**Project:** 4J Security Improvements Projects (2207)  
**Title:** Addendum No. 003  
**Date:** April 7, 2023  
**From:** KC Eck, PIVOT Architecture  
**To:** Interested Bidders

1. This Addendum is in response to Bidder questions and some revisions made during the bid walk through.

**2 FLOOR PLAN - NEW CONSTRUCTION**  
1/8" = 1'-0"

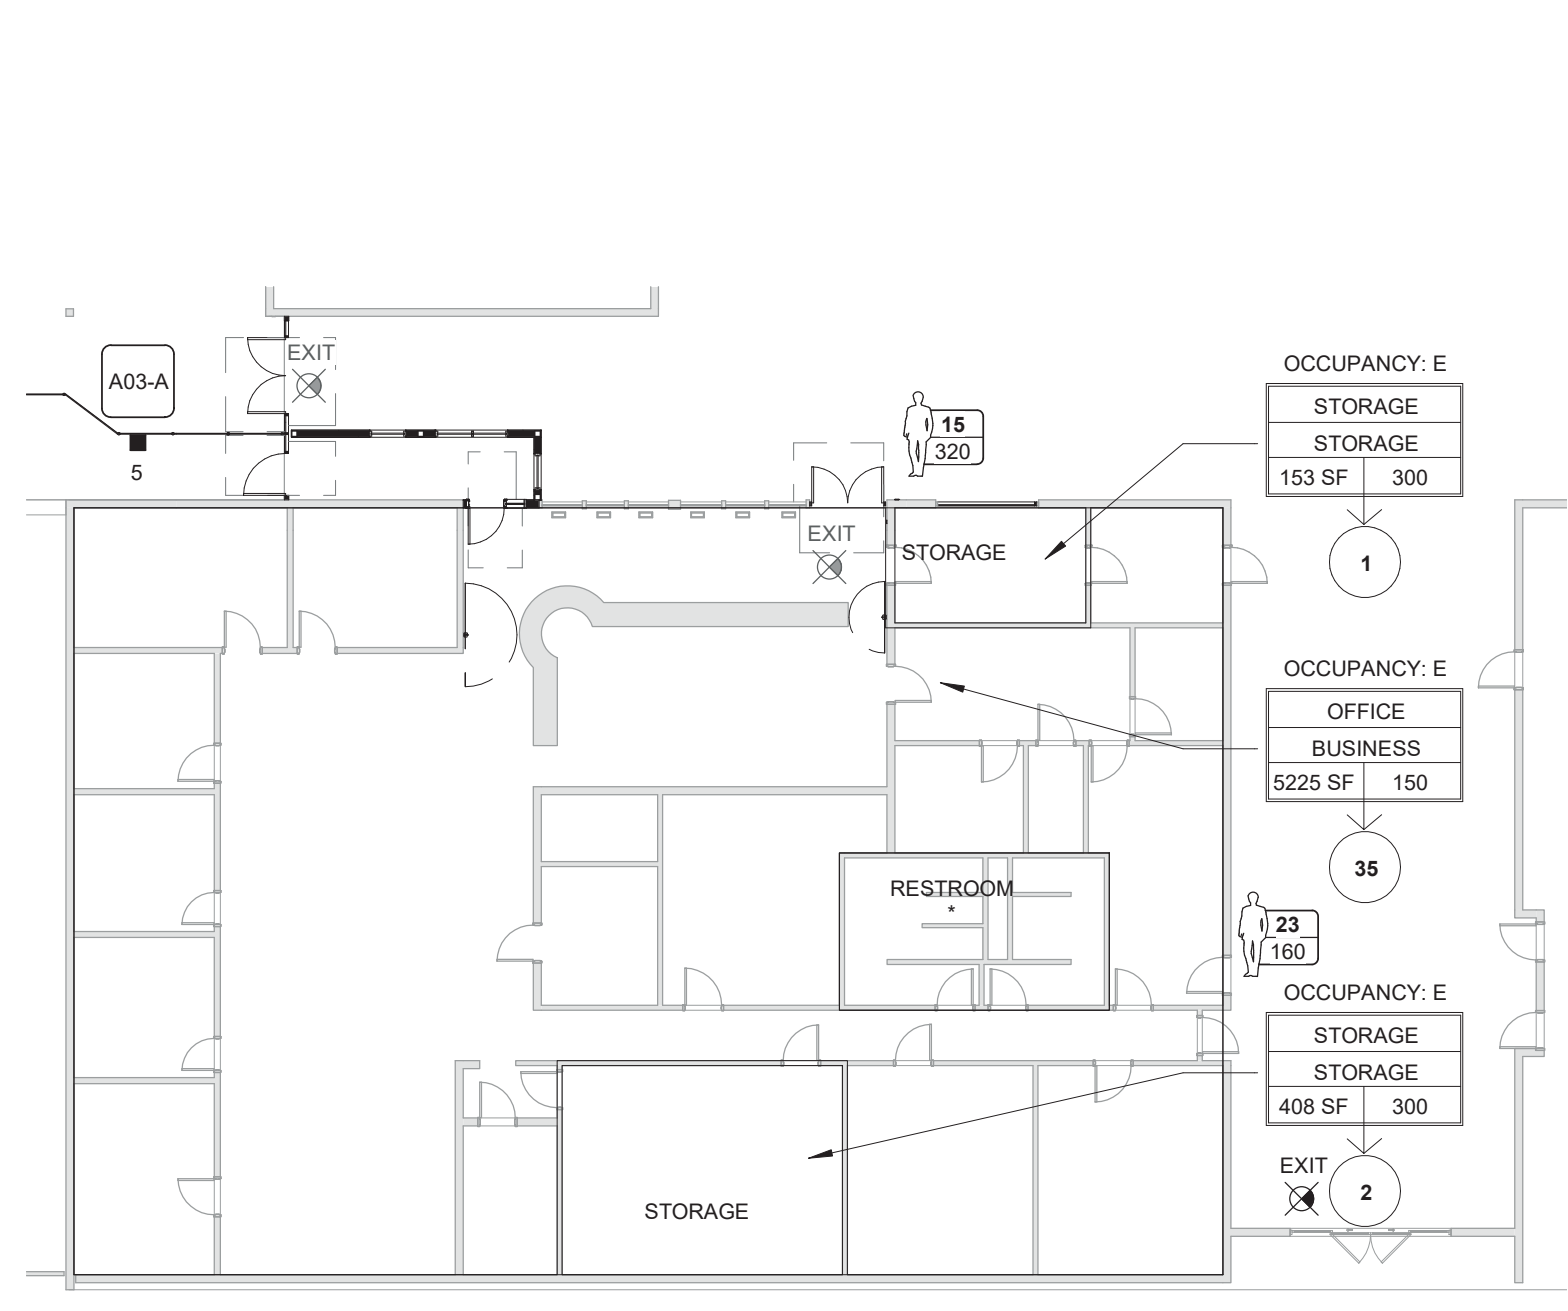
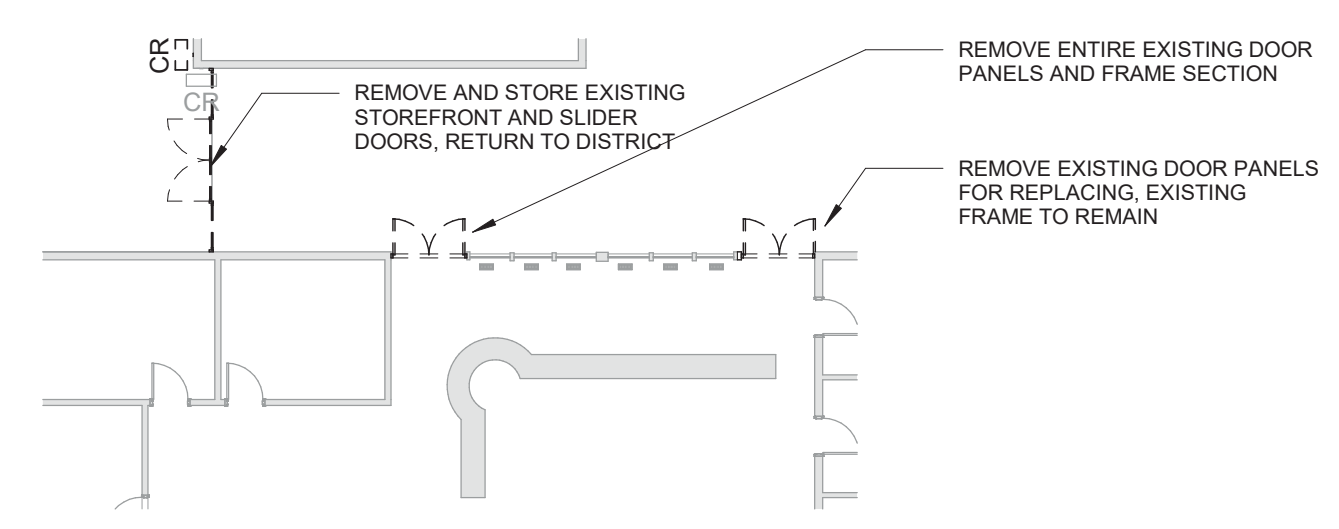
1. Please provide Door, Frame & Relite elevations showing the dimensions & door & frame types.  
*See revised sheets A02-A, A03-A, A03-A, and A05-B*
2. Opening SH2 on the door schedule is showing a width of 4'8". On page A03-A it is showing that the opening has a relite. Is the 4'8" the door size or the out to out of the frame?  
*4'-8" is the frame size, see revised sheets A02-A and A03-A*

**7** DOUBLE GATE SECURED SIDE ELEVATION  
1/2" = 1'-0"

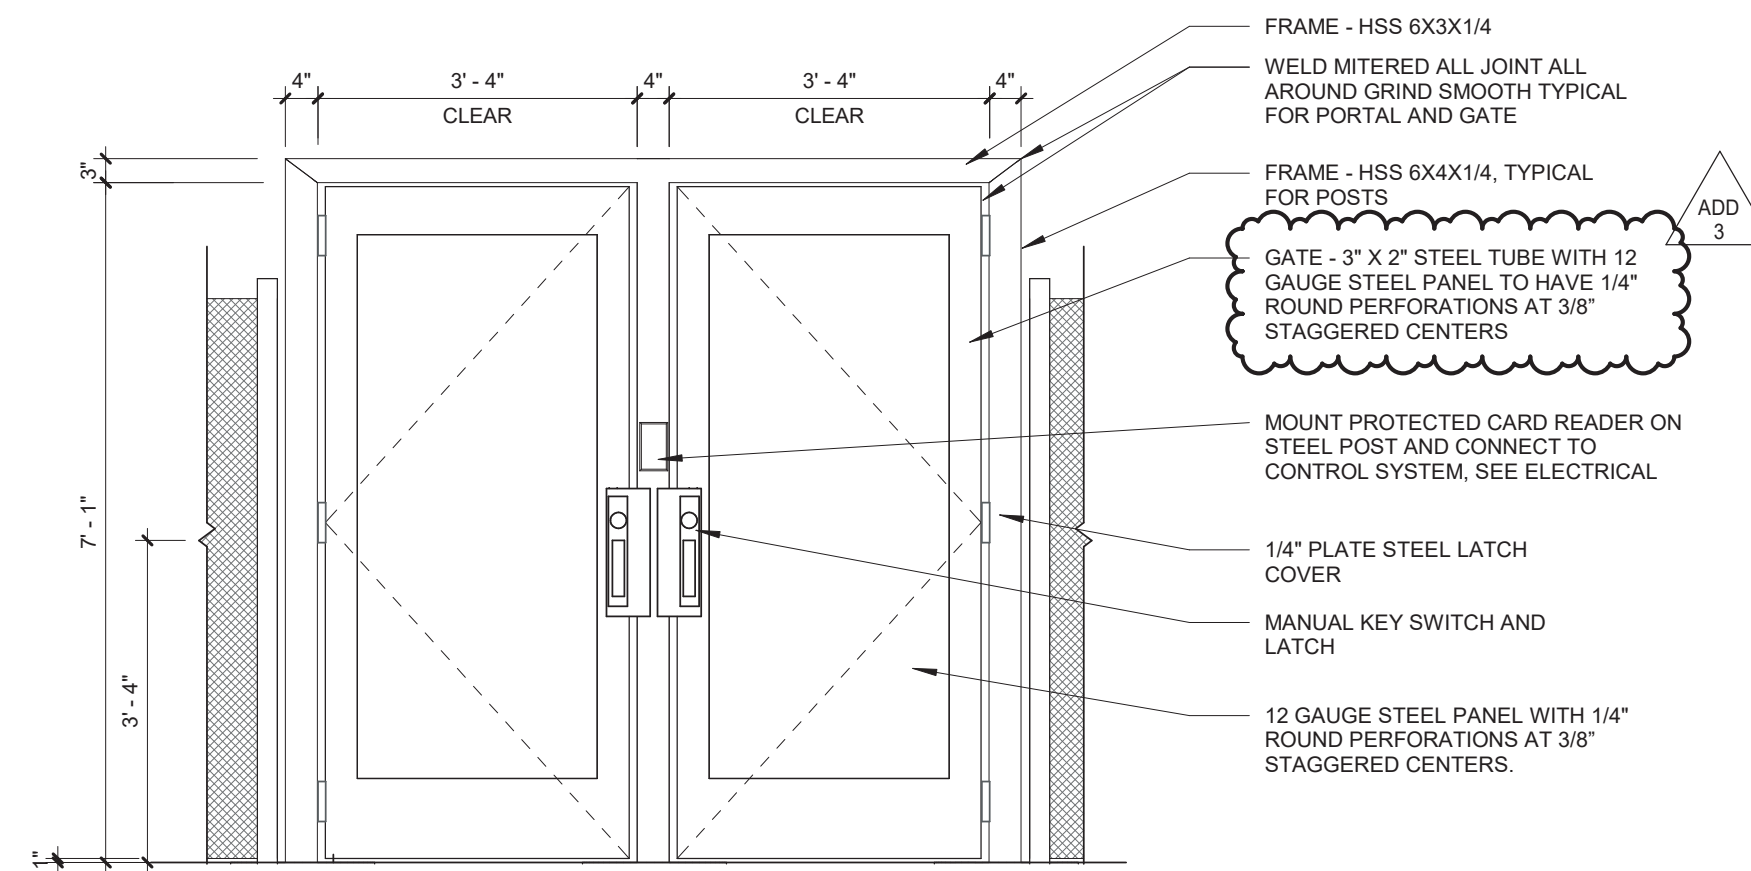
5. Detail 7/A05-A refers to Detail 2/A03-C for note on personal gate. This detail is not found. Please advise.  
*Note has been removed.*
6. Detail 1 & 2/A03-A notes the woven wire size as 4" square while Detail 7/A03-A notes the size as 2" square. Please confirm size.  
*7/A03-A is correct, see revised A03-A*

**4** DOUBLE GATE NON-SECURED SIDE ELEVATION  
1/2" = 1'-0"

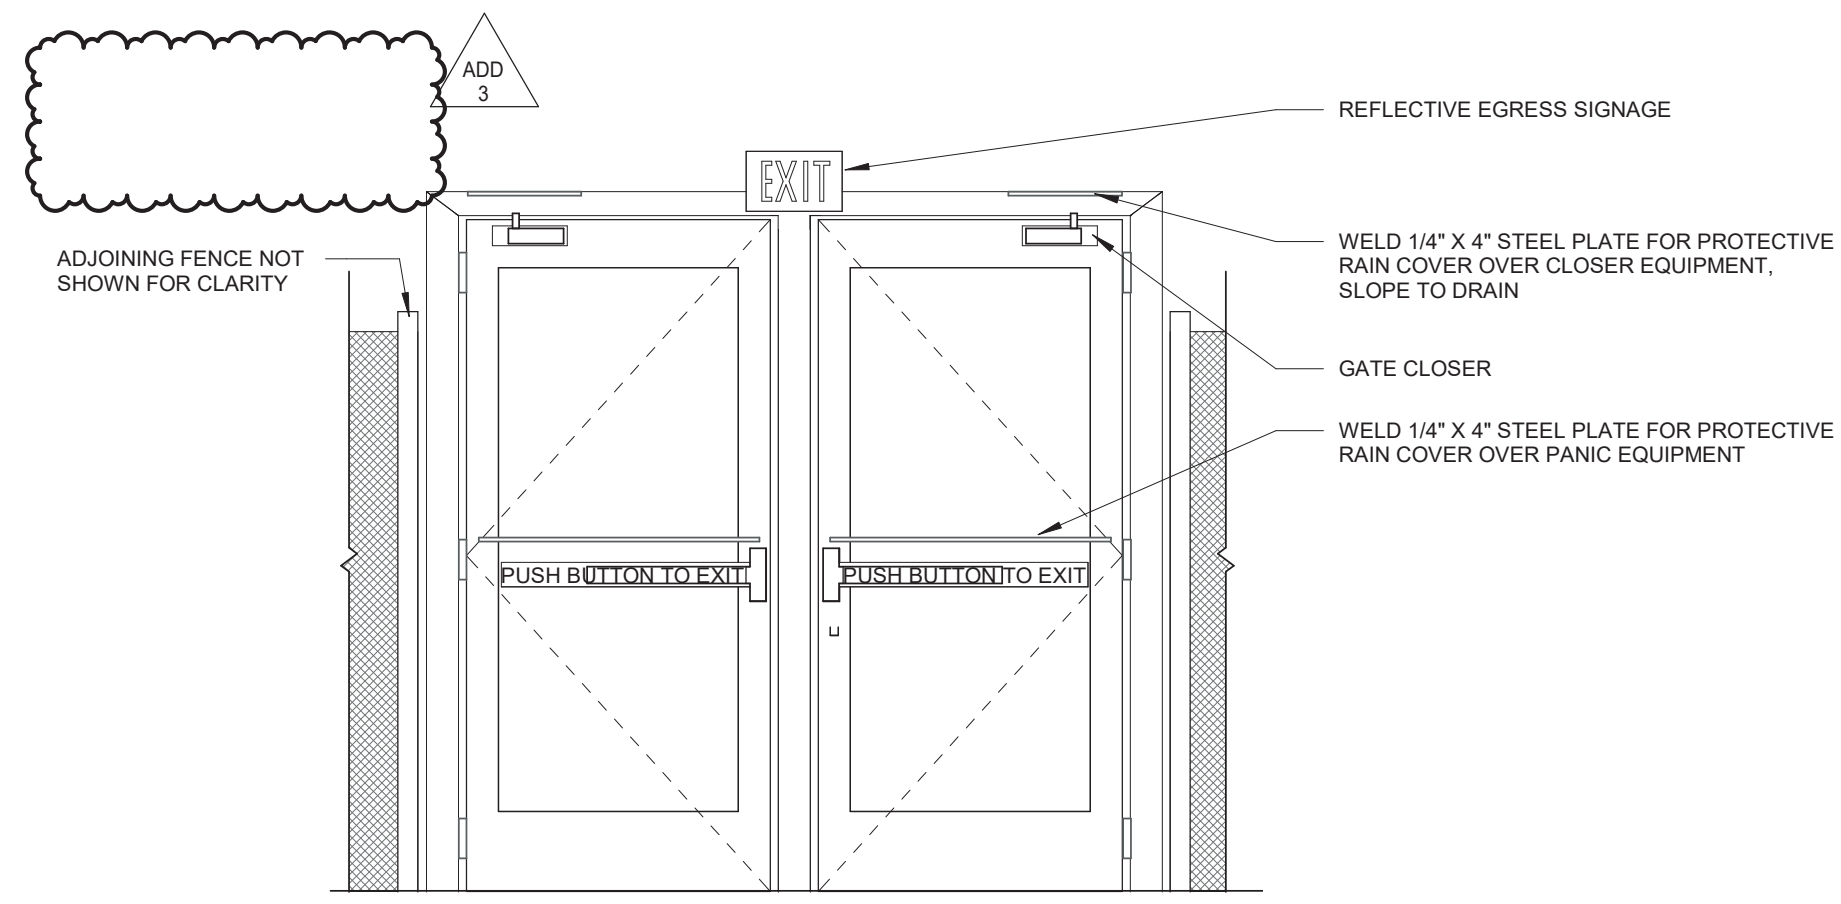
4. Detail 4/A05-A notes the gates will have a perforated panel cover. I am unsure if this refers to Section 05 50 00 Part 2.02; A. Woven Metal Mesh. Please advise.  
*Perforated panel cover is referring to a 12 gauge steel panel with 1/4 round perforations at 3/8" staggered centers, see A05-A*
